**CALIFORNIA GEOLOGICAL SURVEY  
FAULT EVALUATION REPORT FER 253  
SUPPLEMENT NO. 1**

**THE HOLLYWOOD FAULT  
in the Hollywood 7.5' Quadrangle  
Los Angeles County, California**

by  
Janis L. Hernandez  
Engineering Geologist  
November 5, 2014

## **PUBLIC COMMENTS, AND RESPONSE**

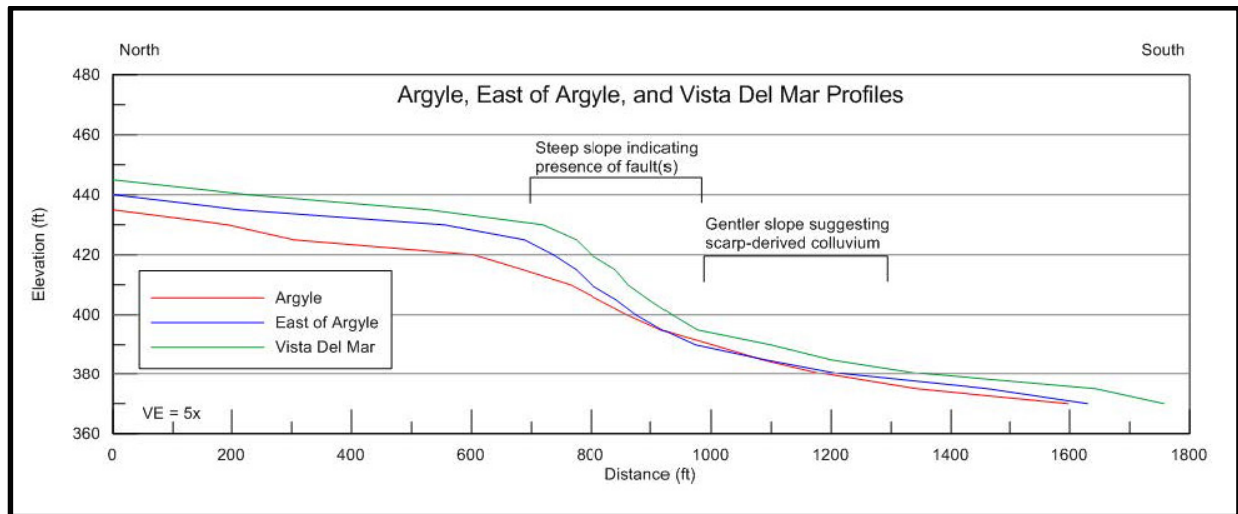
A comment was submitted by Lettis Consultants International, Inc. (LCI), accompanied by a transmittal letter by Elkins Kalt Weintraub Reuban Gartside, LLP on April 8, 2014 to the SMGB to specifically address the BLVD 6200 property located at 6201 Hollywood Boulevard in Hollywood (locality S2-12, Figure 7). In their report, they present data and analysis of the site and vicinity, with additional focus on the southern, discontinuous trace of the Hollywood Fault that is mapped on the Preliminary EFZ map to underlie the site. LCI presented detailed topographic profile analyses consisting of 3 sets of data including: review of historical 6-minute topographic maps, high-resolution lidar imagery, and high resolution ground survey topographic profiles along 8 closely-spaced, north-south oriented streets. These profiles were located within the streets adjacent to the BLVD 6200 site and along other nearby profile lines. They identified breaks in slope within the profiles of these transects, and included locations of scarps previously mapped by Dolan et al. (1997), the projection of fault traces mapped by CGS in FER 253, and the BLVD 6200 project boundary.

LCI stated that in addition to the prominent break in slope located immediately north of their site, a subtle break in slope is expressed across the southern portion of the site. They reported this southern slope break is located south of the southern discontinuous fault trace mapped by CGS. They suggest that subtle breaks in slope can be related to several factors: change in slope direction on the ground surface, or thickness and directional changes within the alluvial fan system. Their analysis noted that the subtle slope break is coincident with an east-west trending apparent scarp mapped by Hill et al. (1979), and a possible fault scarp mapped by Weber et al. (1980). In their review of the 1926 topographic maps, they indicated that Argyle Avenue did not yet exist at this location, and that possibly the subtle break in slope observed in the street may have been created during subsequent construction of Argyle. Alternatively, they concluded that this subtle break in slope reflected in the composite topographic profiles (Figure 13), is most likely related to scarp-derived colluvium from the steep break in slope to the north.

***The data presented in the LCI report was particularly helpful in CGS review of topographic breaks in slope. Fault traces mapped by CGS in this area were based on geomorphic interpretation using similar data as used by LCI, as well as fault traces from Dolan et al. (1997), Hill et al. (1979), and Weber et al. (1980). In addition, the southern discontinuous fault trace was mapped using original subsurface data from Geotechnologies, Inc. (2006) that included logs of borings and the site topographic base map. CGS review of the high resolution street survey data submitted by LCI in their report, and detailed observations included in the Geotechnologies (2013) report, finds justification to modify our interpretation of the location of the principal southern fault trace.***

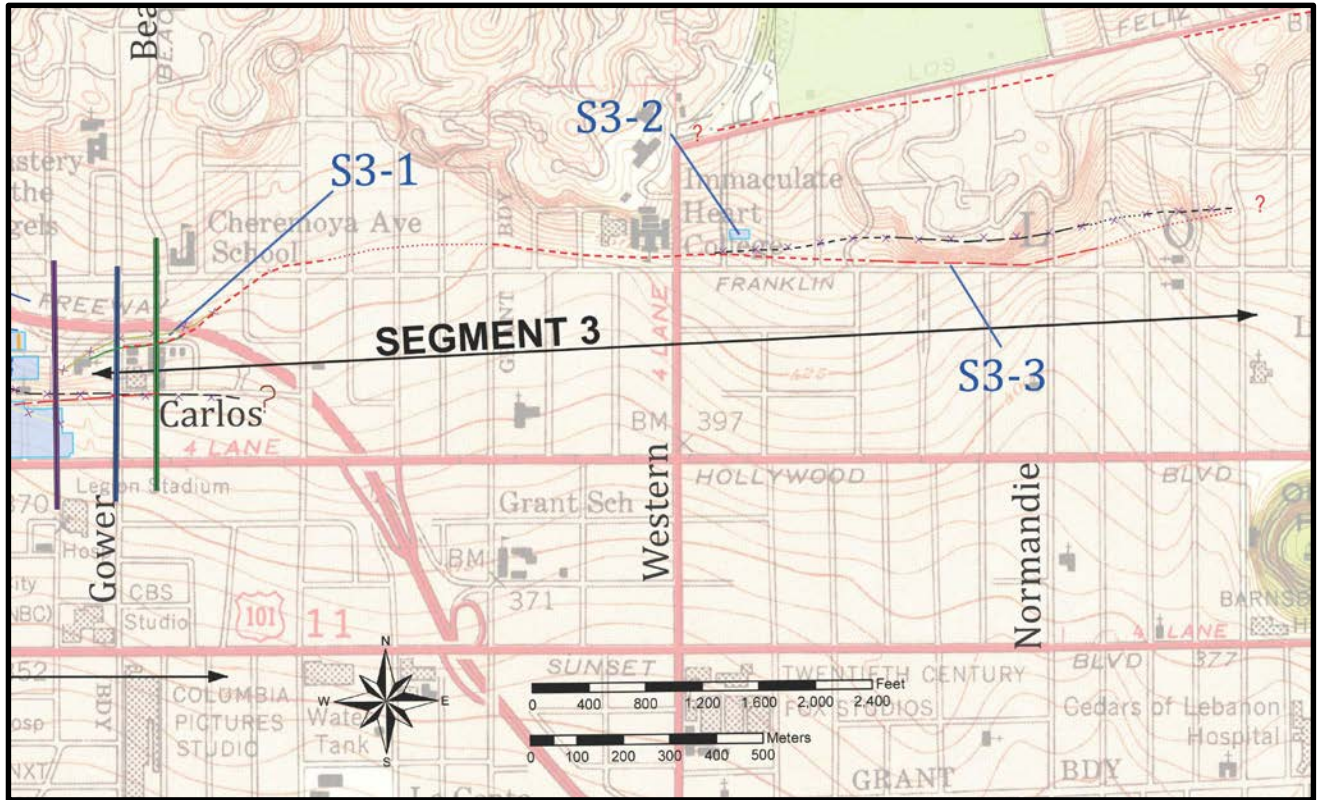
***As described above, LCI (2014) prepared several topographic profiles along north trending streets in the vicinity Yucca Street and Argyle Avenue, which included portions of both Segments 2 and 3. Their analysis included identification of breaks in slope in the area of locality S3-1 (Figure 14). LCI inferred these features were attributed to either: tectonic fault scarps (steep breaks), or alluvial fan or colluvial deposits eroding off the fault scarps (subtle breaks).***

At locality S3-3 (Figure 14), CGS revised the location of the Hollywood Fault trace along Franklin Avenue east of Western, based on a review of the 1926 topographic map covering this area. Our initial interpretation in this area utilized a later version of the topographic map, where topographic details were more subtle. Our reinterpretation of the fault trace follows closely with the trace mapped by Dolan et al, 1997.

***The data presented in the LCI report is helpful for reviewing the magnitude of breaks in slope as they trend from west to east across this portion of Hollywood. As a result, the western portion of the fault trace along Segment 3 appeared to be mapped a few feet north of the base of a subtle break slope, as indicated in the LCI profiles. We have modified the fault trace closer to the base of the slope break as shown in Figure 14. This modification has no effect on the EFZ boundary at this location.***

**As a result of this minor adjustment, the EFZ boundary has shifted slightly to the south.**

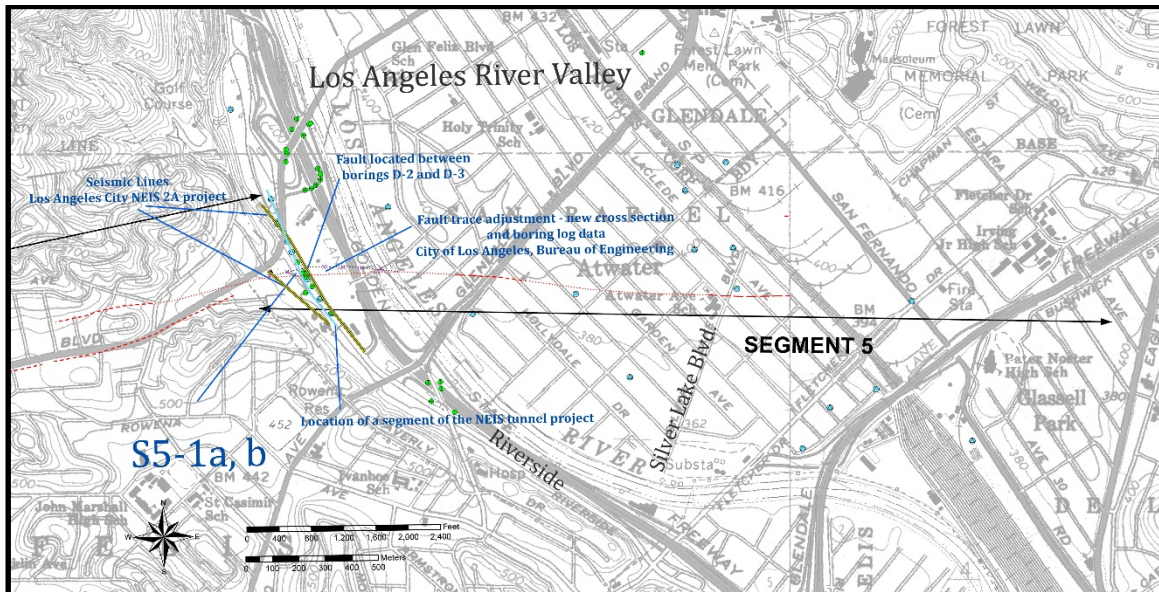
David L. Perry, comment letter dated April 18, 2014: Mr. Perry submitted a comment to the SMGB on April 18, 2014 regarding the location of the Hollywood Fault and analysis of the supporting data from the Northeast Interceptor Sewer (NEIS2A) project area (locality S5-1a) as shown on Figure 15. In this letter, Mr. Perry reports the cross-section utilized in the FER (from the Los Angeles Department of Public Works, 2013) is vertically exaggerated, and includes borings that were projected up to 63 feet horizontally into the section. In the AMEC (2013) report, he states there is a cross-section drawn at a 1:1 scale, and acknowledges subsequent boring data performed by the City of Los Angeles Department of Public Works (City of Los Angeles, 2013) was included in the cross section utilized by CGS for the FER. Mr. Perry's interpretation of the data, and his extensive experience in this area suggests the "thickening of young alluvial deposits within the fault zone" as reported by CGS, is likely attributed to paleochannels from the Los Angeles River system, and that the projection of the data into the cross-section should include consideration of geomorphology and paleochannel geometry.

Patrick Schmidt, and Fred Burnett, (2014): Mr. Schmidt and Mr. Burnett of the City of Los Angeles Bureau of Engineering (BOE) provided CGS a technical paper they prepared in February, 2014 that was submitted to the Underground Construction Association's North American Tunneling Conference (NAT). In this paper, they discussed some of the exploratory methods implemented during the Northeast Interceptor Sewer project (NEIS), including: borings with down-hole geophysics, packer and pressuremeter testing, CPT testing, Remi surveys and surface geophysics lines. They reported some of the difficult conditions they anticipate encountering during tunneling along the fault zone, including: squeezing and running ground conditions, high methane gas concentrations, and up to 5 bars of water pressure. They reported the main Hollywood Fault was located between exploratory borings M08-B4 and M08-B5, where interpolation of the geophysical surface survey data identified two north dipping fault planes with three south-dipping secondary faults in the hanging wall that merge at depth.

City of Los Angeles (2013) conducted an additional fault study that included 3 borings that were drilled during April - May 2013 for the NEIS 2A sewer project. These borings were drilled to further define the limits of the deep older alluvium associated with the active trace of the Hollywood Fault at locality S5-1b. The borings also helped to define the artesian groundwater pressures, depth of bedrock, and methane concentrations they will likely encounter during tunneling operations.

City of Los Angeles (2014) prepared an updated cross-section with location map showing the investigation sites along the NEIS tunnel alignment. This new cross-section included the locations of the 3 borings presented in the 2013 report at locality S5-1b (Figure 17).

***We reviewed Mr. Perry's comments, and appreciate the insight he provides in this area, and particularly with his experience on the NEIS project. Regarding projection of data into the NEIS profile, we acknowledge the thickness variation of recent alluvium in the vicinity of subsurface faulting may be due to erosion processes, and paleochannel morphology along the ancestral Los Angeles River system.***

***This technical paper describes conditions the City of Los Angeles BOE will encounter during tunnel excavation operations. No additional details regarding active faulting either outside or within the tunnel alignment were noted. However, their description of difficult tunneling conditions keys into the general width and local structure of the fault zone along the west bank of the Los Angeles River Valley.***

***Our review of the updated cross section and boring logs received from the City of Los Angeles (locality S5-1b), finds that the original projected surface trace of the fault should be shifted to the south approximately 90 feet. We have revised the location of the fault trace based on this new cross section and supporting data. A corresponding revision of the zone boundary has been made.***
